Subject: **PALO VERDE SOLAR 1, LLC'S INITIAL COMMENTS ON THE STAFF
ASSESSMENT/DRAFT ENVIRONMENTAL IMPACT STATEMENT
DOCKET NO. (09-AFC-6)**

Application for Certification for the
BLYTHE SOLAR POWER PROJECT

DOCKET NO. 09-AFC-6

**PALO VERDE SOLAR 1, LLC'S INITIAL
COMMENTS ON THE STAFF
ASSESSMENT/DRAFT
ENVIRONMENTAL IMPACT
STATEMENT**

Soil and Water
Figure 7
Northern Transect
TDS in Groundwater -
Mesa vs. Floodplain

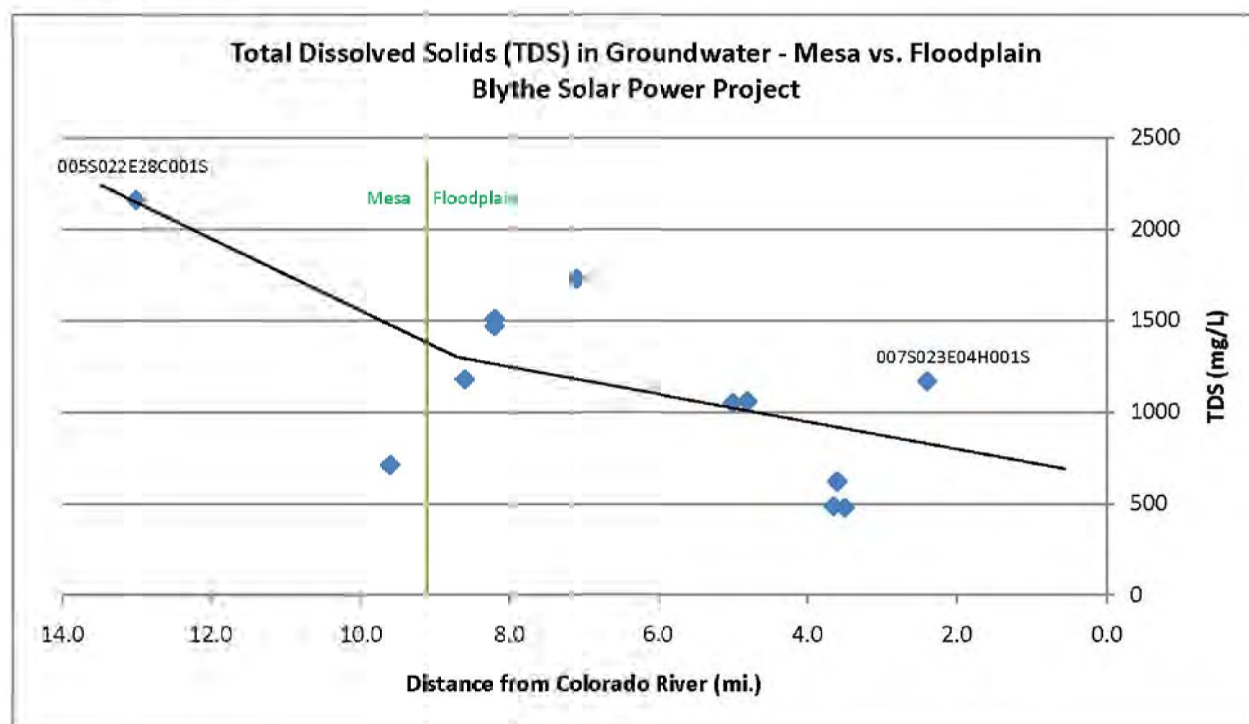
Soil and Water - Figures -7 through 13, are transects for two locations from the river and area north of the Project site and through the Project site. The graphs illustrate TDS, chloride, boron and fluoride concentrations with increasing distance away from the Colorado River. They provide additional data showing the changes in water chemistry, and thus water sources for the flood plain and the mesa.

PLOT PLAN
AIR COOLED CONDENSER OPTION

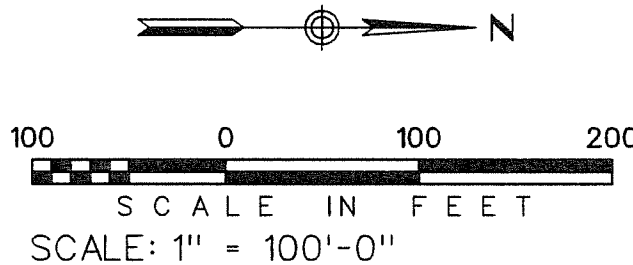
These changes are reflected in the attached drawing 2008-045E-PP-001ALT, Plot Plan, Air Cooled Condenser Option for a revised plot plan and power block layout.
